Re: Catawba Nuclear Station, Unit 1
Docket No. 50-413
Proof and Review Technical Specifications

Please find attached proposed changes to the Proof and Review Technical Specifications for Catawba Unit 1. These changes reflect corrections to errors presently contained in the Specifications.

FIGURE 3.2-1

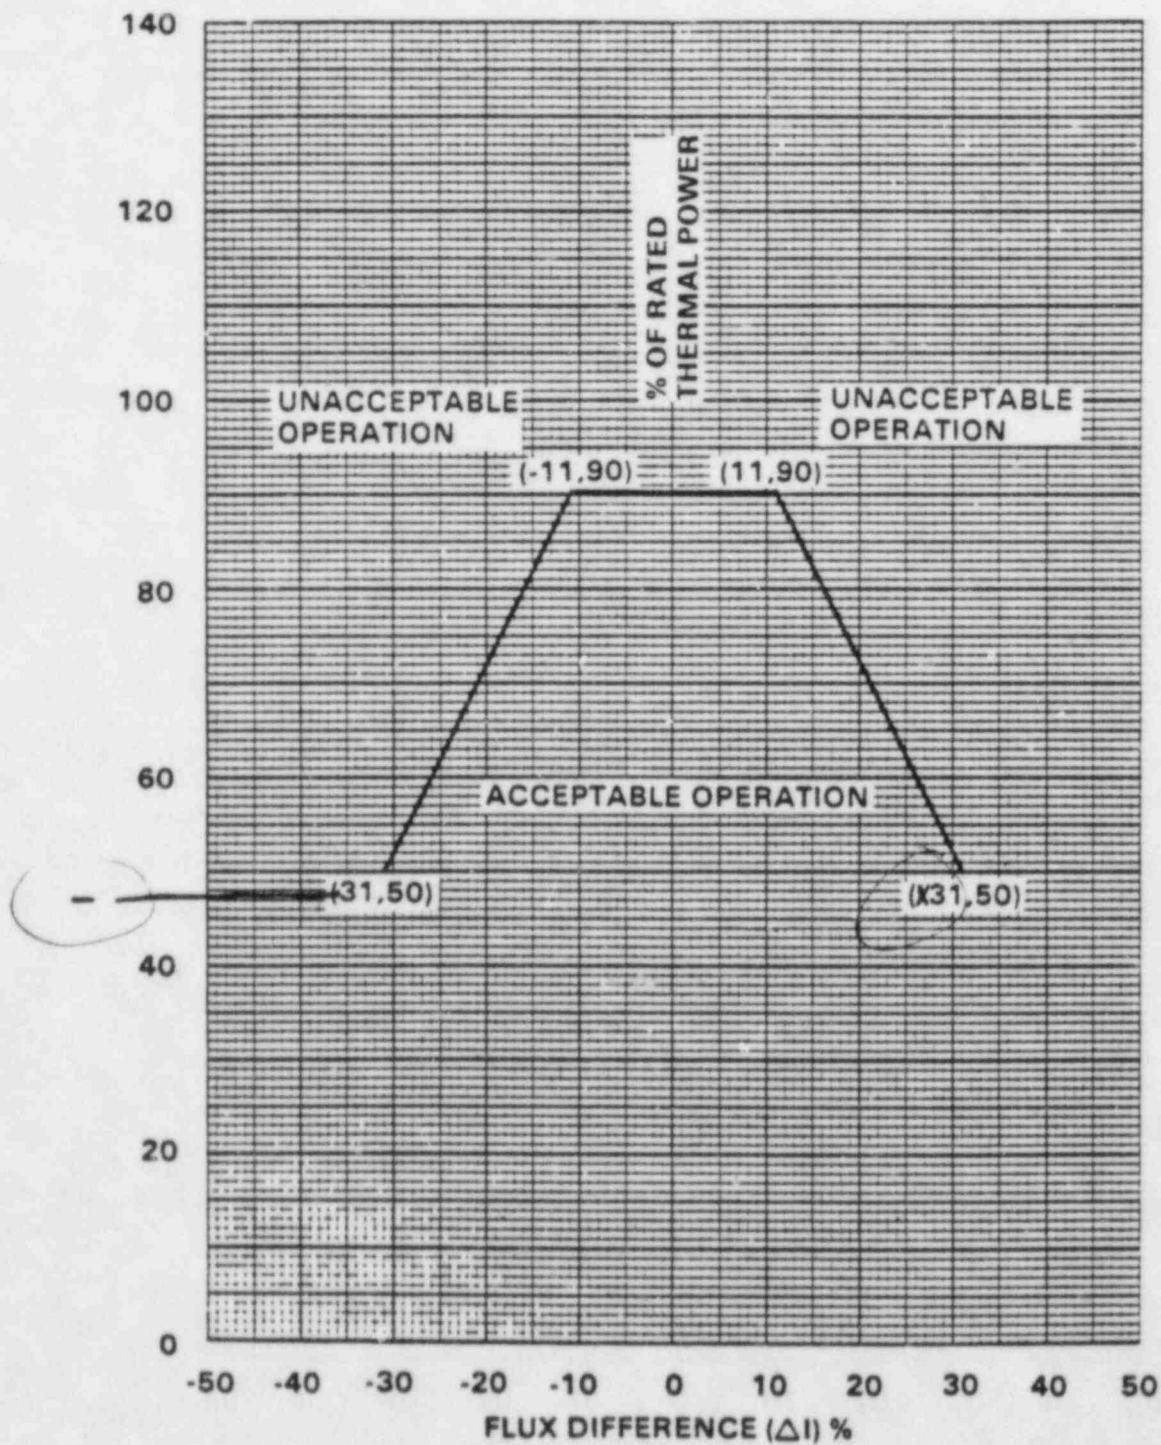
AXIAL FLUX DIFFERENCE LIMITS AS A FUNCTION OF
RATED THERMAL POWER
